FREEDOM OF INFORMATION ACT REQUEST (FOI 2019-00199)

This letter is in response to the electronic Freedom of Information Act (FOIA) request you submitted to this office requesting “written comments submitted to the Department of Energy in response to the Department’s Notice of Availability of the Draft Waste Incidental to Reprocessing Evaluation for Closure of Waste Management Area C at the Hanford Site...”

WMA C Conceptual Model

Figure S-14. Lifetime Radiological Risk for the Drinking-Water Well User at the Core Zone Boundary due to Releases from Tank Farm Sources Other Than Past Leaks

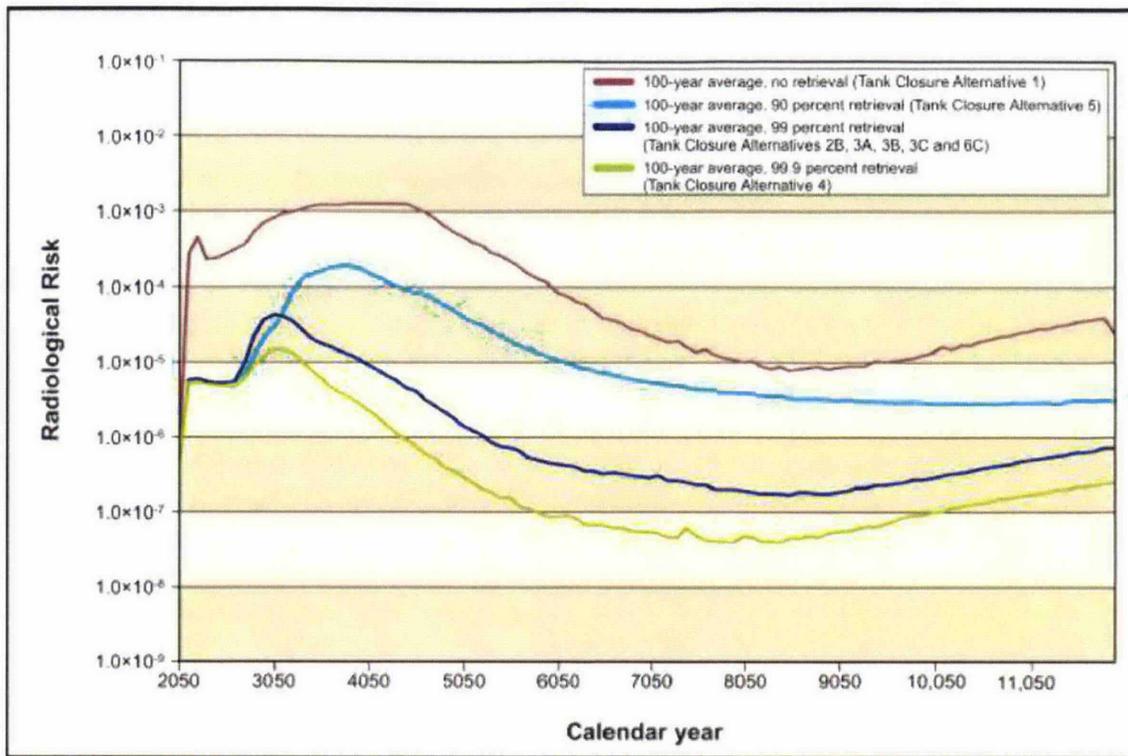
Comment: The TC&WM EIS states that *“...DOE prefers Tank Closure alternatives that would retrieve at least 99% of the tank waste.* It is not clear that the desired objective of 99% or greater removal has occurred in WMA-C. Data in the WIR evaluation indicate that waste retrieval activities at the WMA-C recovered approximately 96% by volume of the waste in the 100 and 200 Series tanks. This reviewer recognizes that the volume fraction removed does not necessarily equate to the removal fraction of individual species, but data on the fraction removed for individual isotopes and hazardous chemicals was not evident in the document. What are the implications on the analysis and conclusions derived from the TC&WM EIS if 99% removal of the radionuclides and hazardous waste did not occur within WMA-C? Figure S-14 of the TC&WM EIS (duplicated below) depicts the predicted risk from groundwater for various levels of waste removal. The maximum risks for 90% retrieval and 99% retrieval are between 10^{-5} and 10^{-4} . Risks associated with 96% retrieval will fall between these results, and thus are substantial.

Requested action: Please indicate the removal fraction achieved for individual isotopes and hazardous chemicals. If 99% efficiency was not achieved, address the impacts on the analysis and conclusions derived from the TC&WM EIS. Is the USDOE prepared to defend a decision to leave the site in a state that will create future radiological risks to the public that are at or near 10^{-4} as indicated by the above figure? Note that the figure clearly indicates the computed risk is only accounting for Tank Farm sources OTHER than past leaks. Hence, the contribution from other waste disposal areas or past soil contamination are not represented and radiological risks may be even higher.

Page 2-74, Lines 12-14, text stating: “Figure 2-25 shows the conceptual model of an SST shortly after the emplacement of the grout, while Figure 2-26 shows the conceptual model of an aged tank system.”

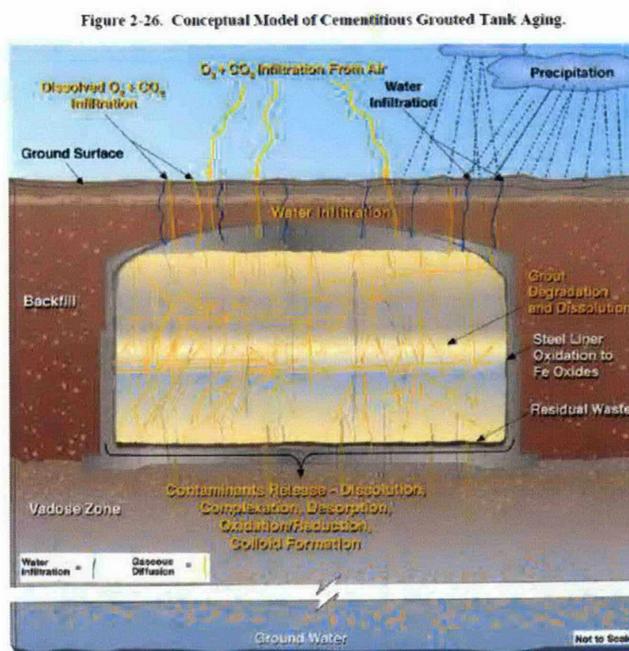
Comment: The residual tank waste in Figure 2-25 and 2-26 is depicted as a uniform layer. Section 6.2.1.1 of the WMA-C PA indicates that this waste geometry was assumed for the Performance Assessment modeling. Furthermore, Section 6.2.2.1.1 of the Performance Assessment states:

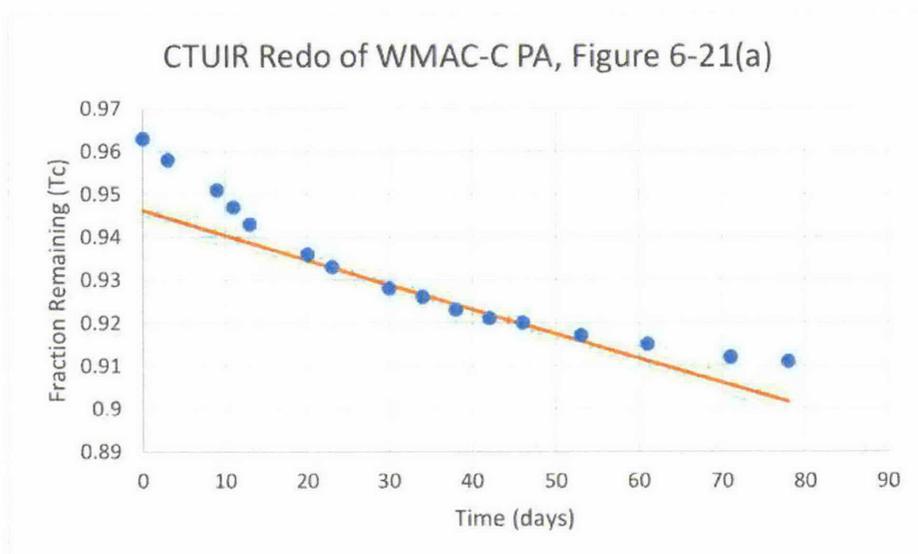
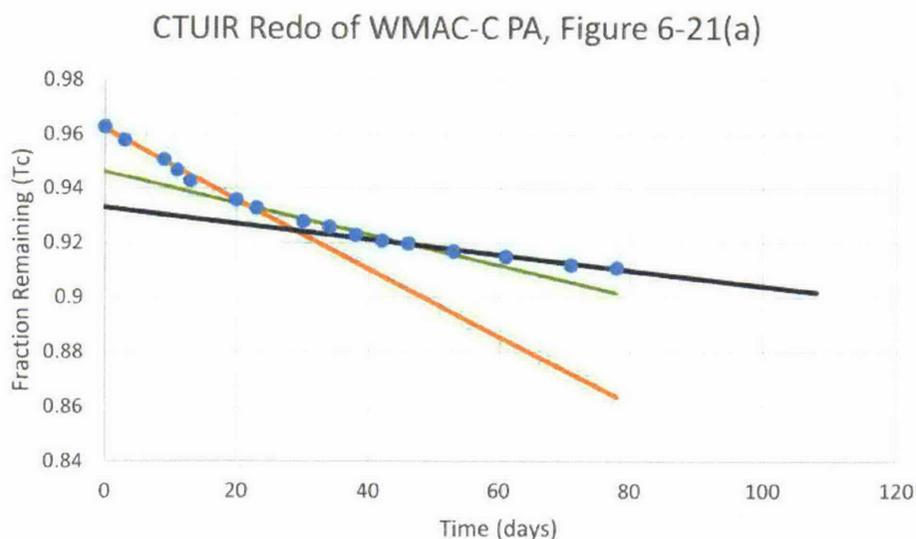
Comment: Figures 6-20 through 6-23 of the WMA-C PA depicts experimental results used to derive the source release model for 99Tc. The lower portions of each figure indicates the results for a best fit of a first order release rate model to the data. The following is a recreation of this fit done by this reviewer for the data in Figure 6-21:

Blue points represent a recreation of the data (estimated from the figure) and the orange line is predicted fraction modeled in the same manner as reported in the WMA-C-PA. Namely, the data between approximately 20 days and 53 days were fit to the equation:

and k were found to be 0.95 and -0.0006 (day⁻¹), respectively. These values are near those reported in Figure 6-21 (0.94 and -0.0006).

It is clear from the figure that a first-order rate model does not fit the data and that a fundamentally different conceptual model is needed. This assertion is made for several reasons. First, if the release of ⁹⁹Tc were first order in ⁹⁹Tc mass then the release rate would be expressed as:

It appears to this reviewer that the release of ⁹⁹Tc in the experiments may be occurring by at least two separate mechanisms, one being rapid and the other being slower. If two mechanisms were considered then the early portion of the data may be dominated for the former and the later data by the slower mechanisms. The mid-range data represents a transition period when both mechanisms are contributing to the release of the ⁹⁹Tc.

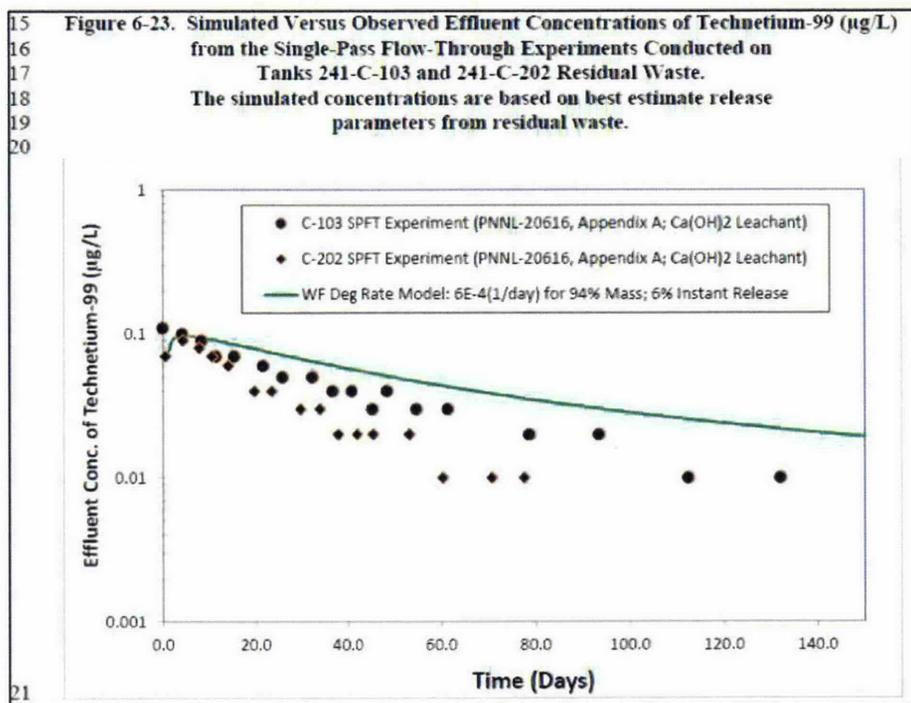
Use of a first-order release model and the coefficient derived as indicated in the WMA-C-PA to estimate long-term release of ⁹⁹Tc will create substantial errors in estimated ⁹⁹Tc in the environment. This error is abundantly evident in WMA-C PA Figure 6-23 (reproduced below):

Furthermore, assessing uncertainty in the first order rate coefficient (see WMA-C-PA Section 8.1.3.3) will not bound the potential error since the form of the model is fundamentally incorrect.

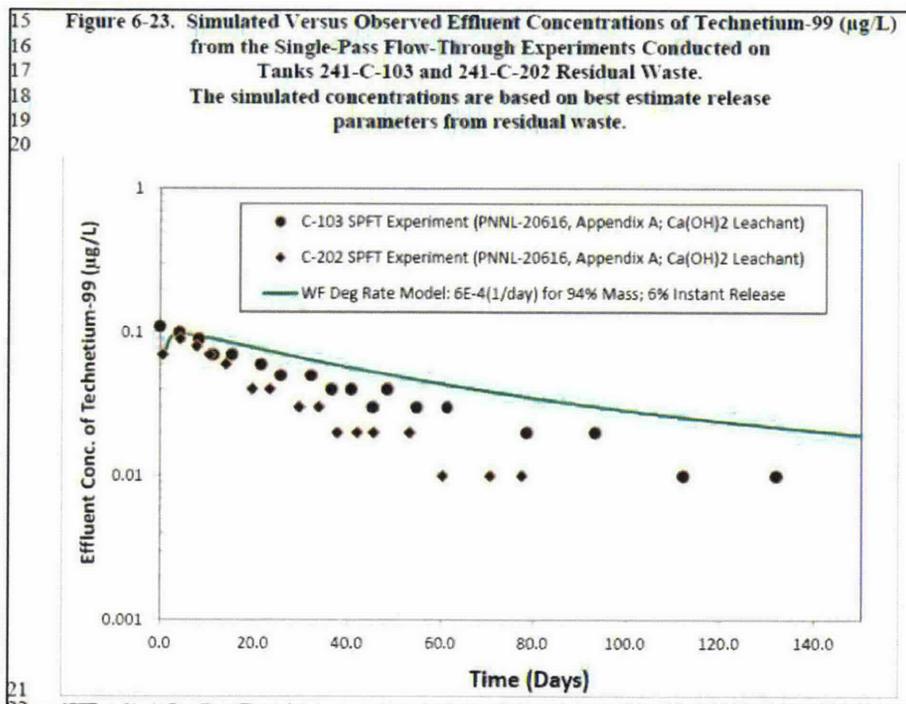
Comment: The ^{99}Tc release model depicted in Figure 6-23 of the WMA-C PA (reproduced below) over-predicts leaching. This phenomena will result in predicted groundwater concentrations of ^{99}Tc peaking higher and earlier than would occur with a release rate that better fits the data. The Performance Assessment states this is a conservative assumption. However, since the possible dose from other radiological compounds increase at later times, holding ^{99}Tc within the tanks longer may result in a larger total peak exposure than currently predicted (see Figure 7-31 RPP-ENV-58782, Rev. 0).

Requested action: Please consider the impacts of a slower release of ^{99}Tc on the overall groundwater pathway effective dose.

Page 5-3, Section 5.2, General Comment on the All Pathways Scenario.

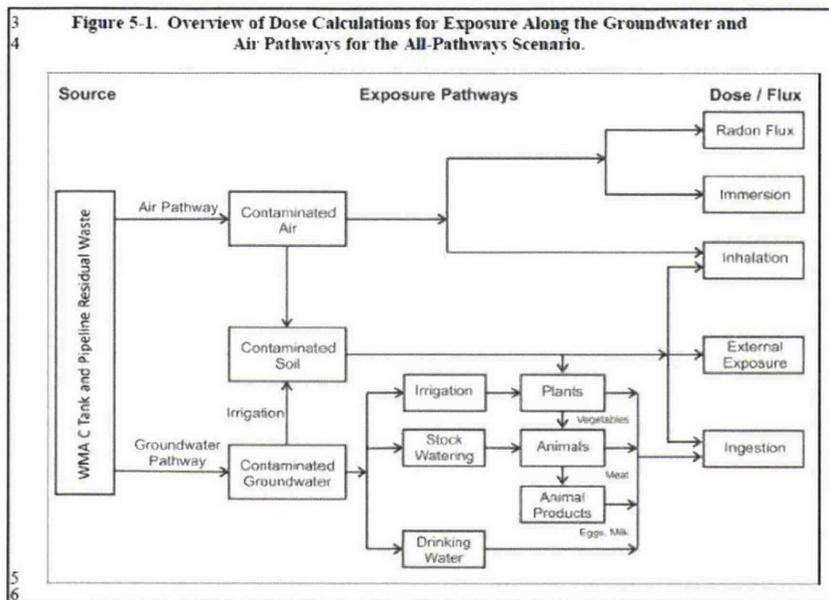
Comment: The “all pathways” scenario used to assess protection of the general public assumes exposure via the following pathways:

The conceptual model assumes a hypothetical individual resides at the boundary of the DOE-controlled area until the assumed period of active institutional controls ends at 100 years. At this time, the person moves to the point of maximum exposure at, or outside, the 100-m buffer zone. Exposure occurs through the transport of contaminants to the receptor through the use of groundwater to drink, to grow crops, and to water livestock. Only contaminants from tanks and ancillary equipment is considered. Exposure also results from contact with soils contaminated by the application of groundwater and through inhalation of gaseous species that diffuse from the subsurface into the breathing zone and are transported to the point of contact at the edge of the 100-m buffer zone. Three exposure mechanisms are considered for the air pathway; air immersion, inhalation, and external exposure to the contaminated ground surface resulting from wet and dry deposition of a fraction of the waste.
